Attachment 2

Proposed Technical Specification Changes

Unit 1 Technical Specifications

Unit 2 Technical Specifications

FIGURE 3.2-1 AXIAL FLUX DIFFERENCE LIMITS AS A FUNCTION OF RATED THERMAL POWER

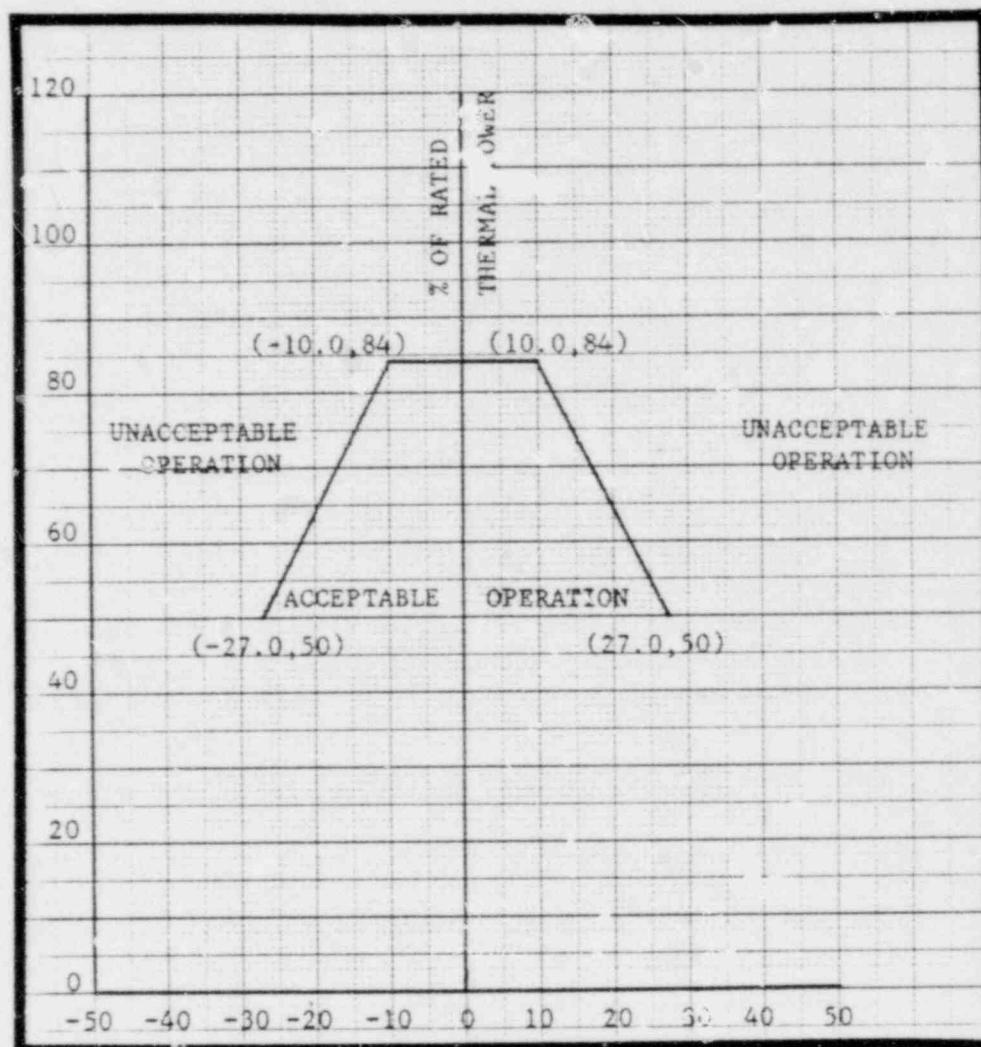
- 2) The indicated AFD is within the limits shown on Figure 3.2-1. Otherwise, reduce THERMAL POWER to less than 50% of RATED THERMAL POWER within 30 minutes and reduce the Power Range Neutron Flux-High Trip Setpoints to less than or equal to 55% of RATED THERMAL POWER within the next 4 hours.

- b) Surveillance testing of the Power Range Neutron Flux Channels may be performed pursuant to Specification 4.3.1.1.1 provided the indicated AFD is maintained within the limits of Figure 3.2-1. A total of 16 hour of operation may be accumulated with the AFD outside of the target band during this testing without penalty deviation.

Figure 3.2-2 $K(Z) - \text{Normalized } F_Q(Z)$ as a Function of Core Height

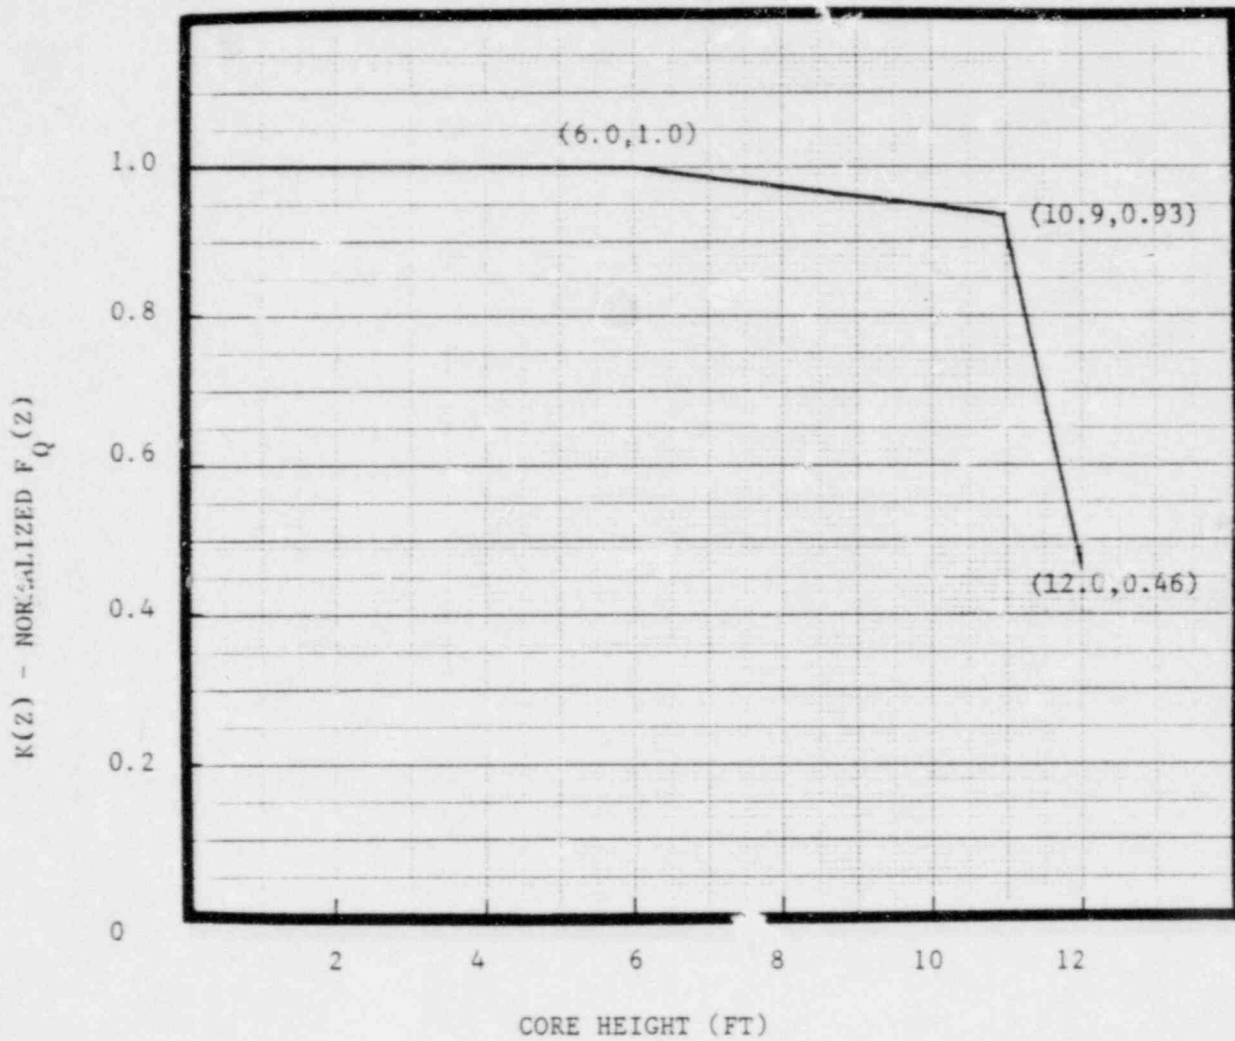
3.2.2 $F_Q(Z)$ shall be limited by the following relationships:

$$F_Q(Z) \leq \frac{2.14}{P} [K(Z)] \text{ for } P > 0.5$$

$$F_Q(Z) \leq 4.28 [K(Z)] \text{ for } P \leq 0.5$$

and $K(Z)$ is the function obtained from Figure 3.2-2 for a given core height location.

Figure 3.2-1 Axial Flux Difference Limits as a Function of Rated Thermal Power

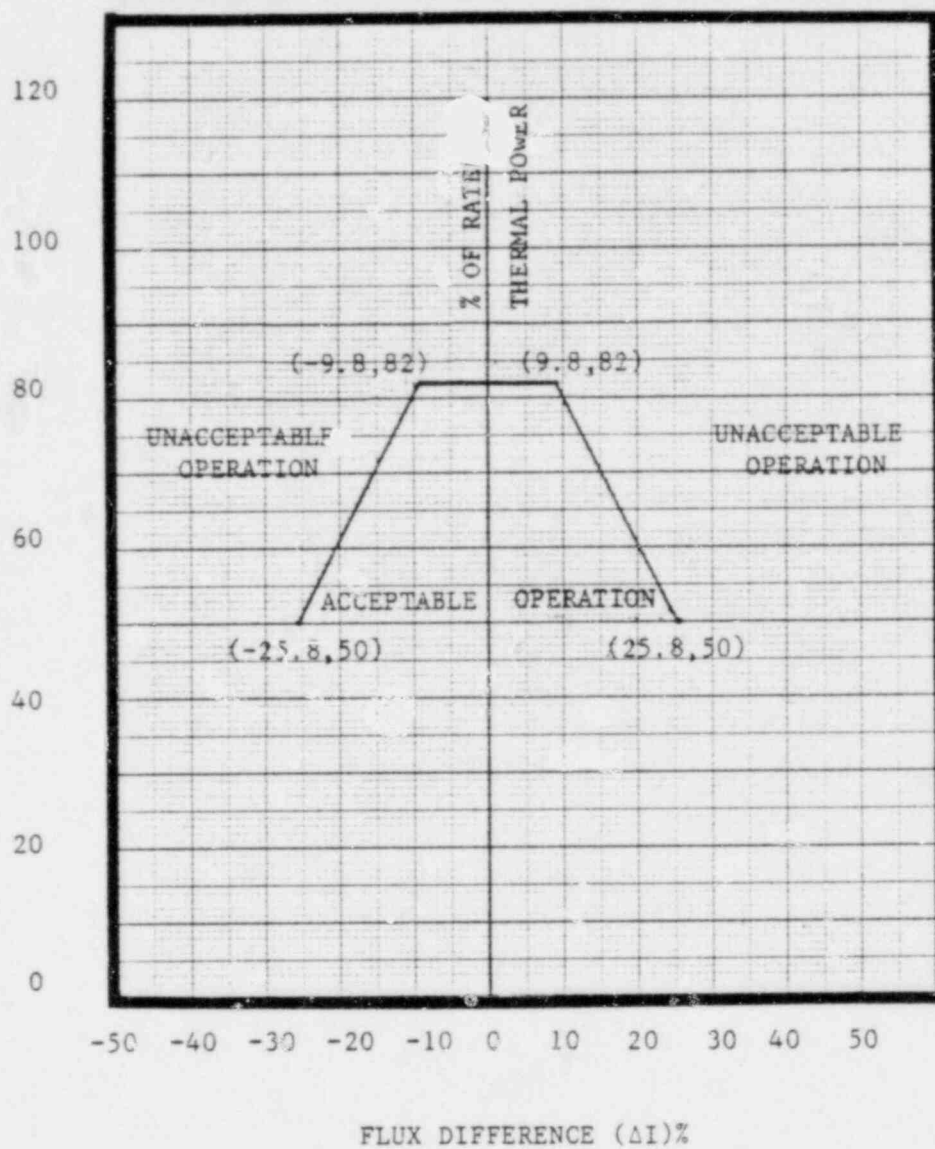
- 2) The indicated AFD is within the limits shown on Figure 3.2-1. Otherwise, reduce THERMAL POWER to less than 50% of RATED THERMAL POWER within 30 minutes and reduce the Power Range Neutron Flux-High Trip Setpoints to less than or equal to 55% of RATED THERMAL POWER within the next 4 hours.

- b) Surveillance testing of the Power Range Neutron Flux Channels may be performed pursuant to Specification 4.3.1.1.1 provided the indicated AFD is maintained within the limits of Figure 3.2-1. A total of 16 hours of operation may be accumulated with the AFD outside of the target band during this testing without penalty deviation.

Figure 3.2-2 $K(Z) - \text{Normalized } F_Q(Z)$ as a Function of Core Height

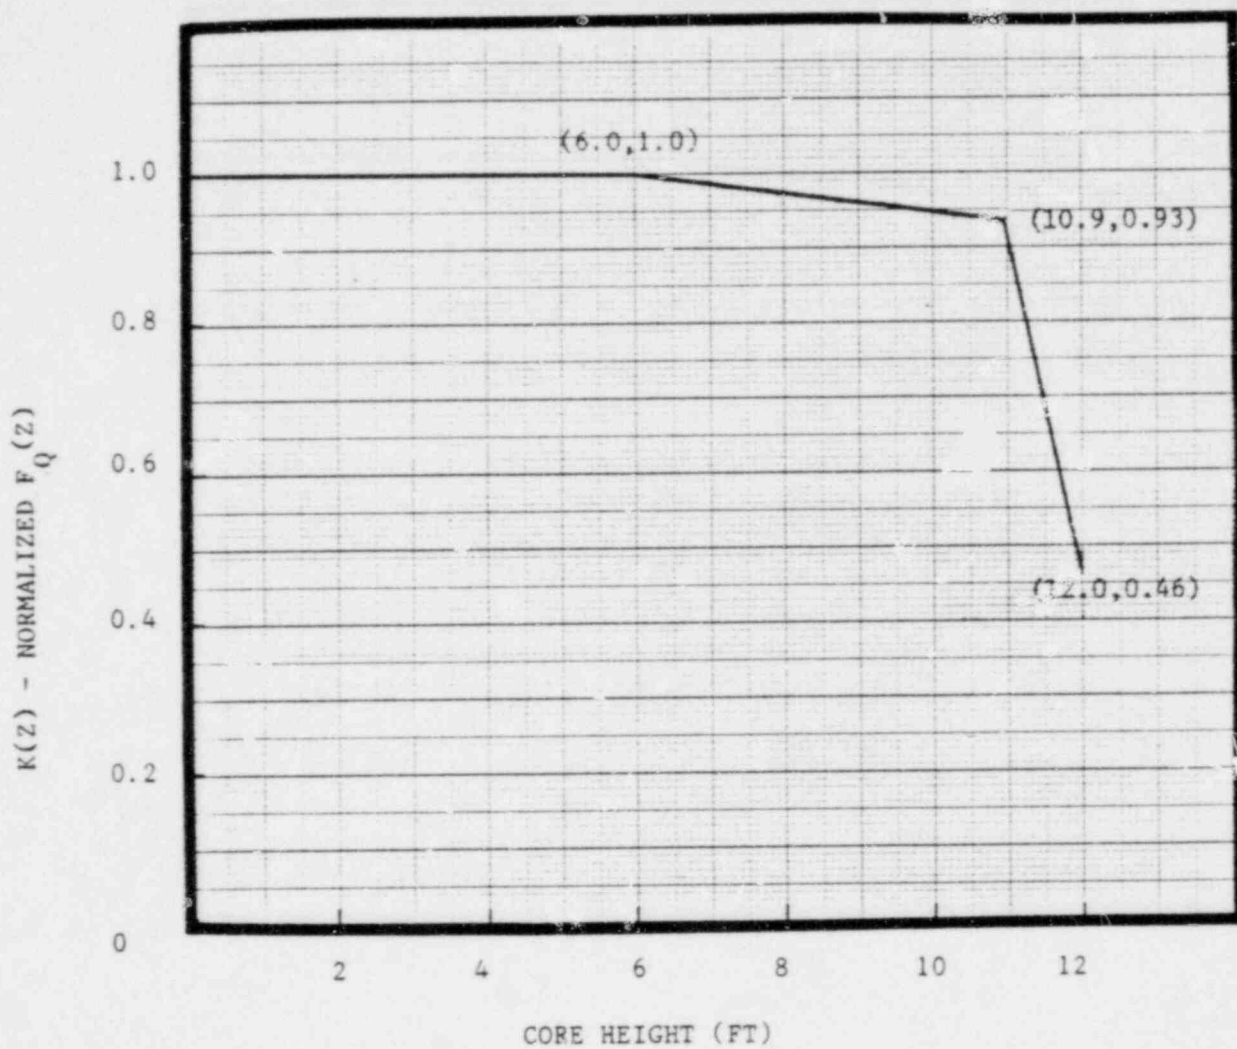
3.2.2 $F_Q(Z)$ shall be limited by the following relationships:

$$F_Q(Z) \leq \frac{[2.14]}{P} [K(Z)] \text{ for } P > 0.5$$

$$F_Q(Z) \leq [4.28] [K(Z)] \text{ for } P \leq 0.5$$

and $K(Z)$ is the function obtained from Figure 3.2-2 for a given core height location.
